Project No. 2021\_154

MIDLOTHIAN ISD STADIUM ADDITIONS AND RENOVATIONS

ADDENDUM NO. 2

DATE: October 18, 2021

7 METAL PANEL AT ROOF EAVE  
3" = 1'-0" REF 2 / A-303

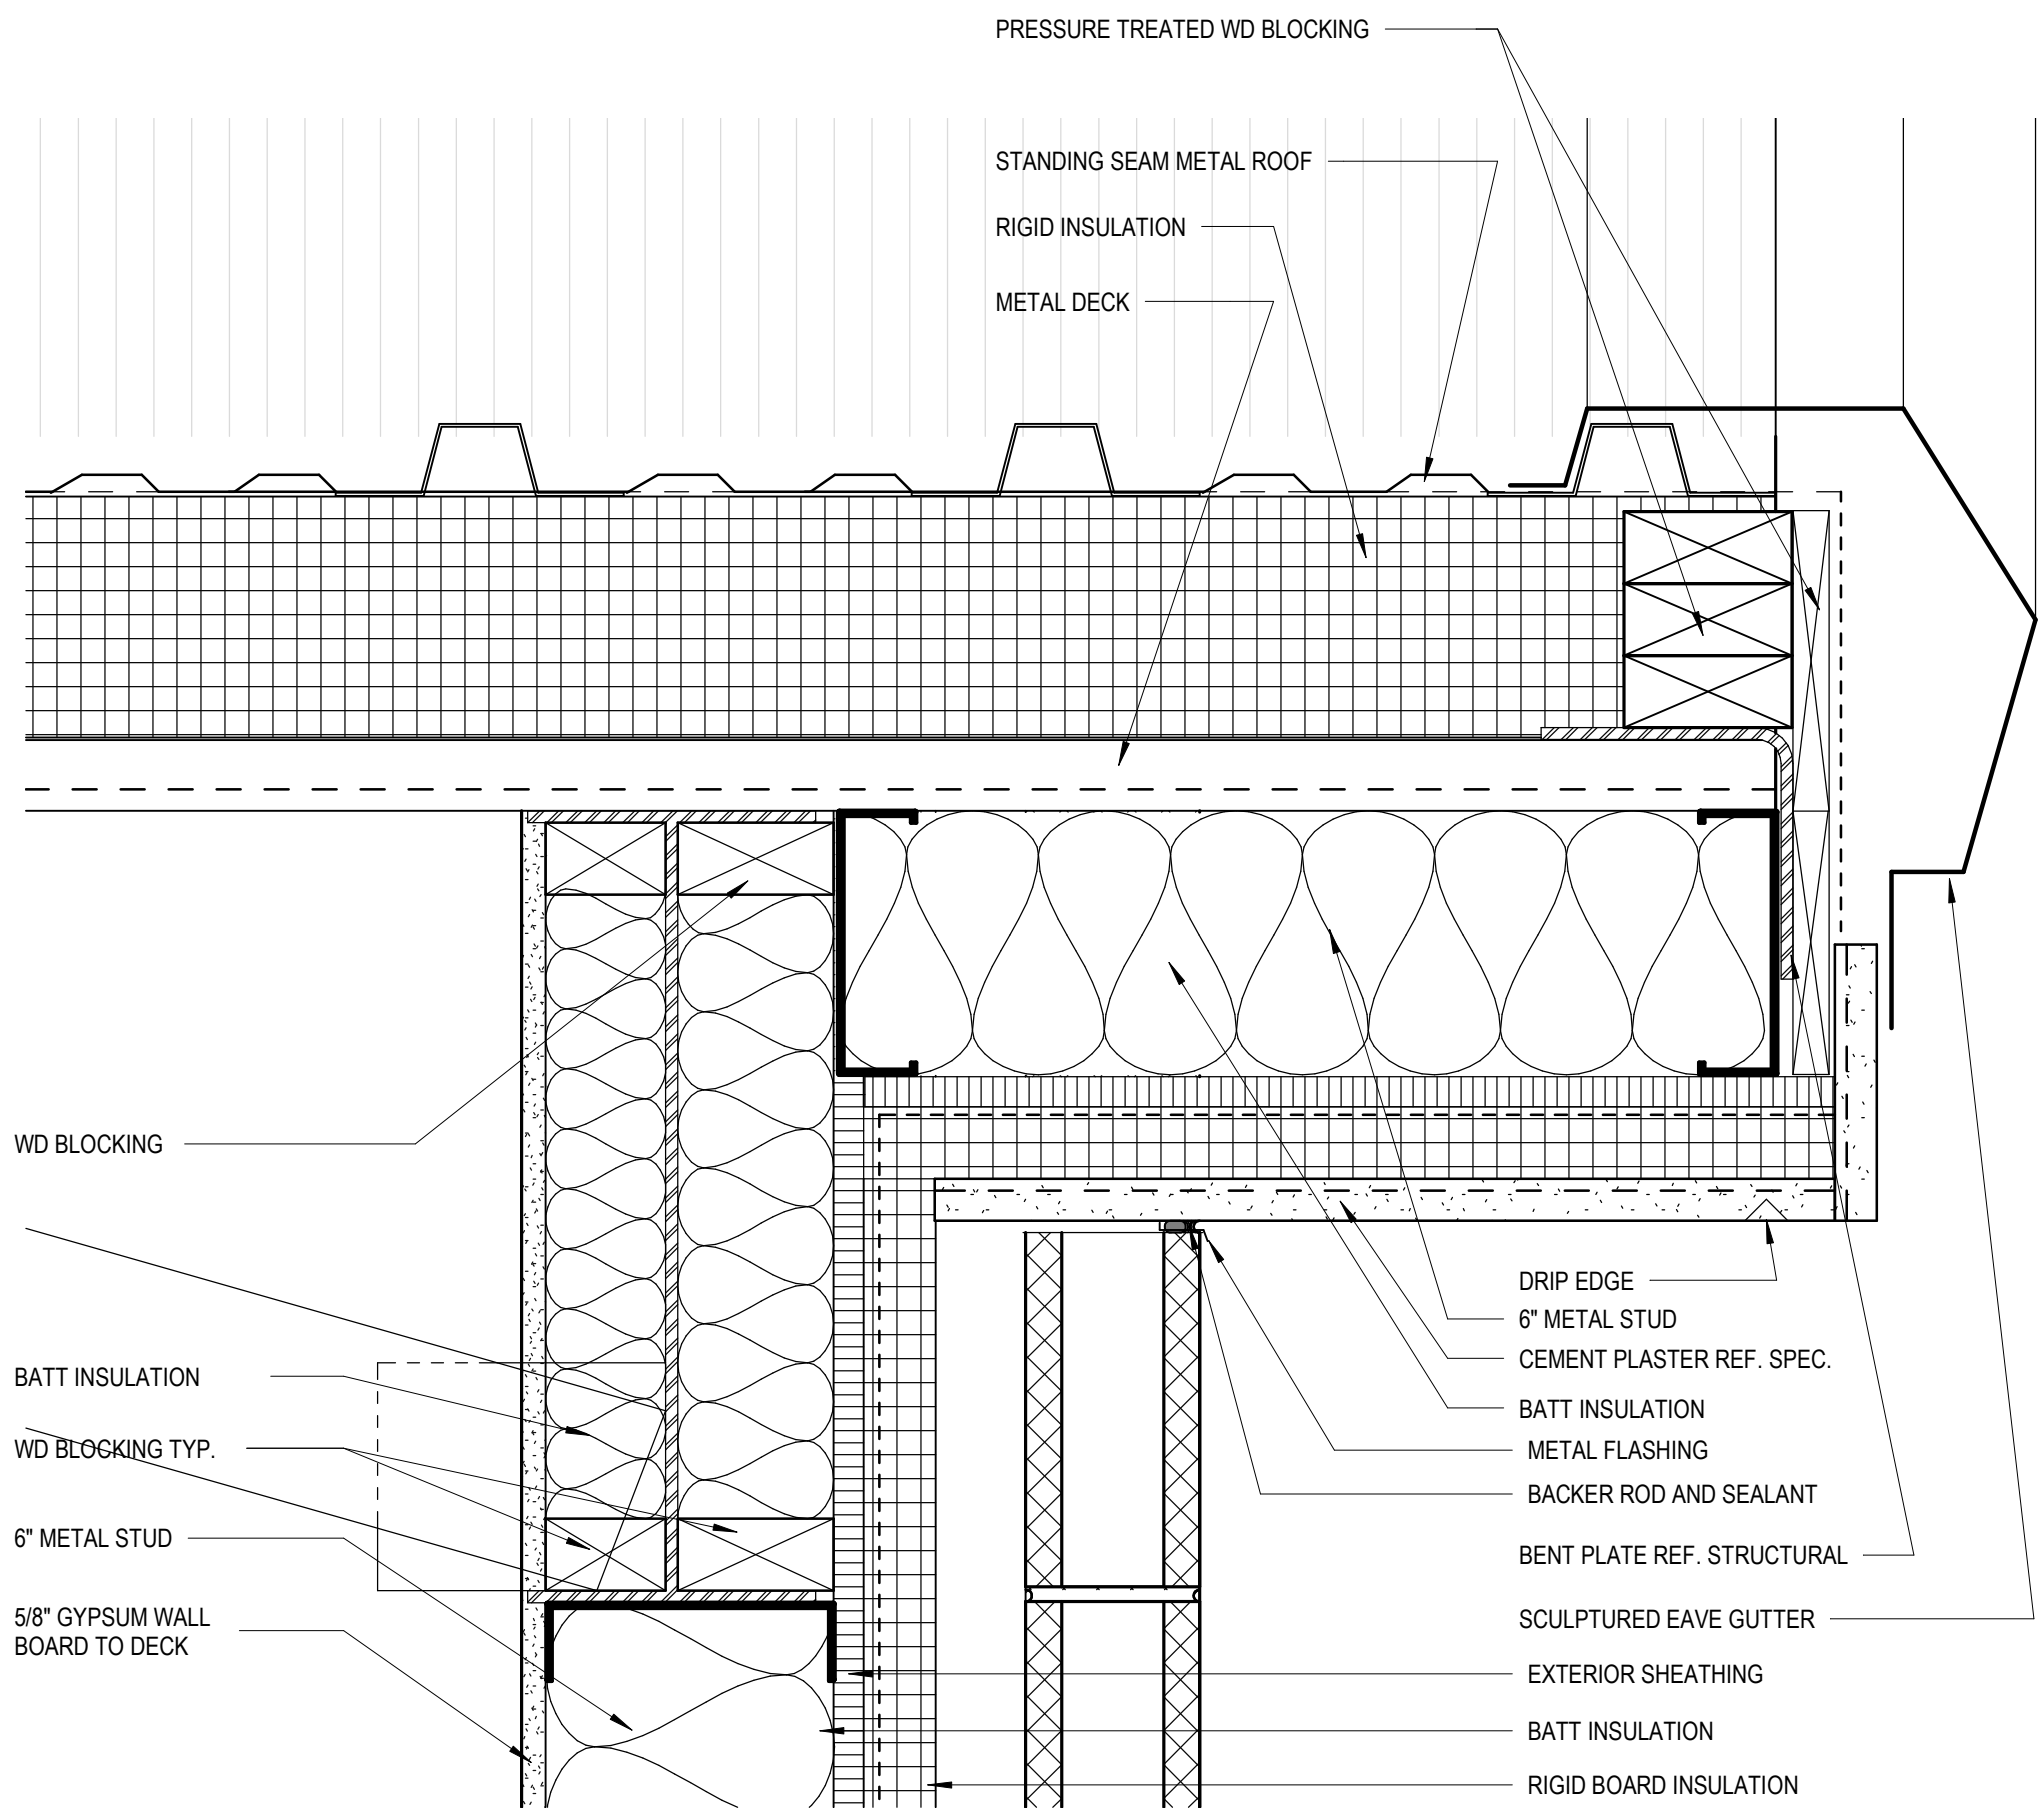
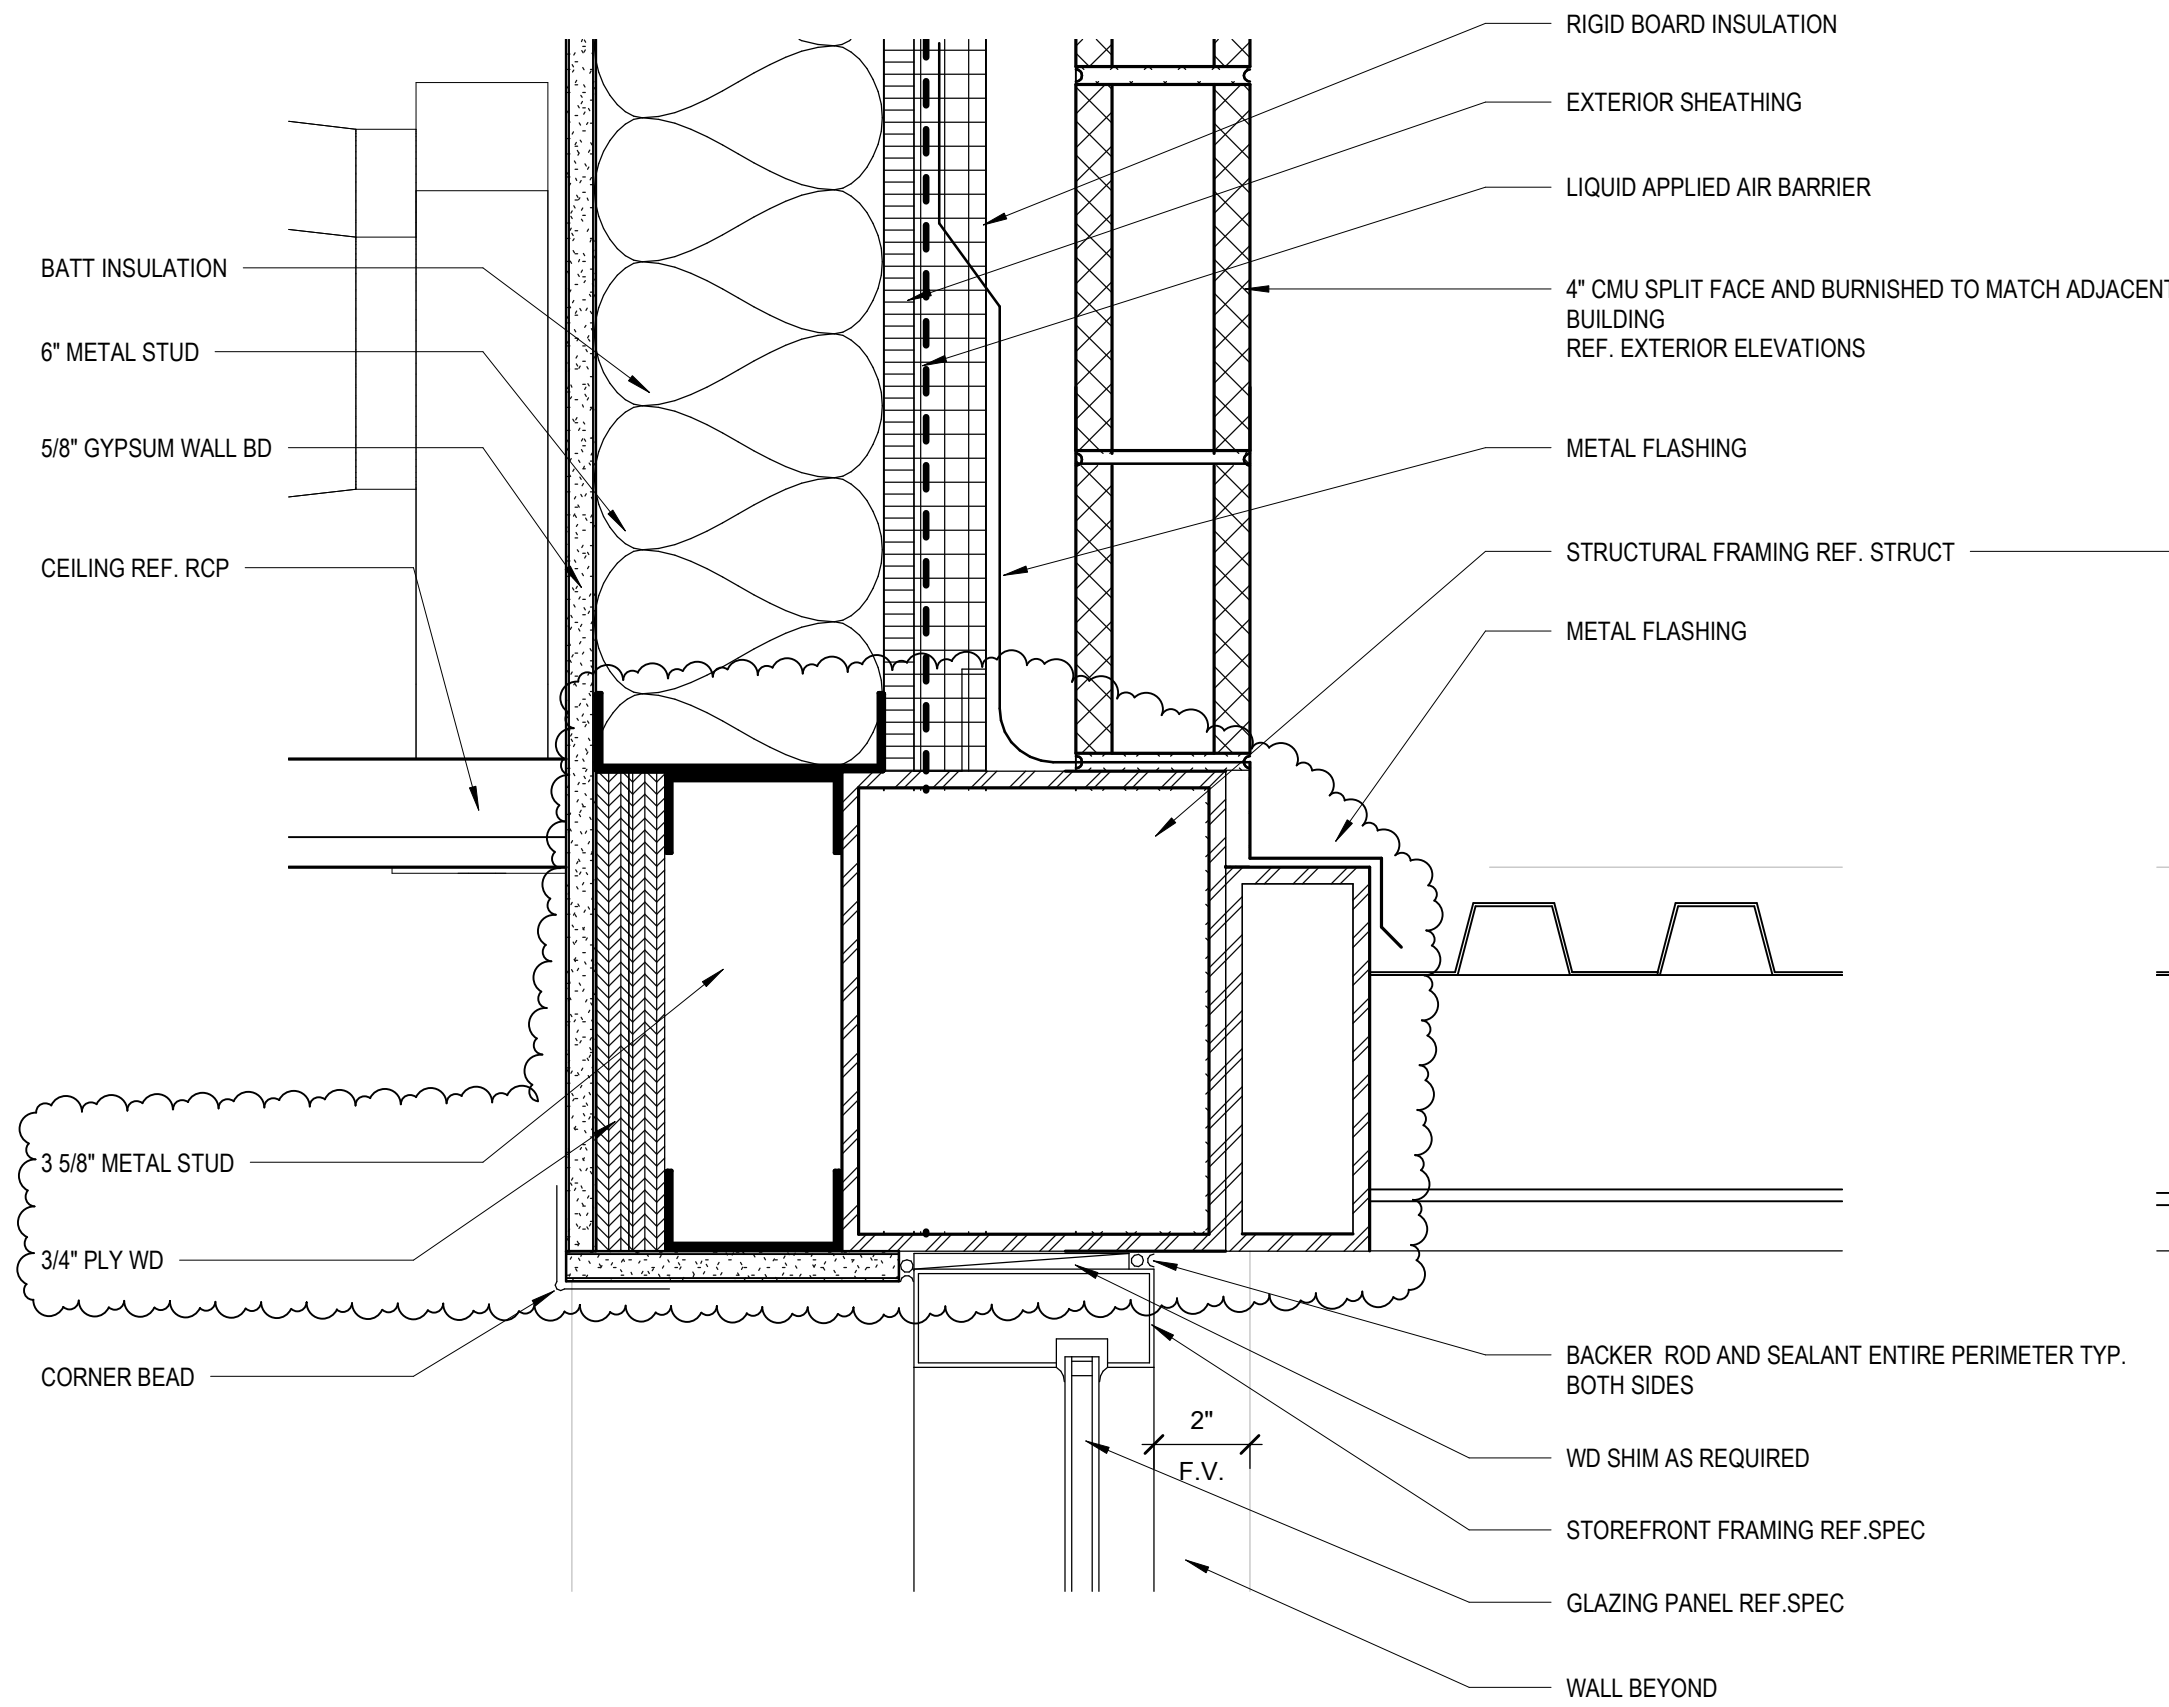
- a. REVISED structural tube beam to correct location per structural.
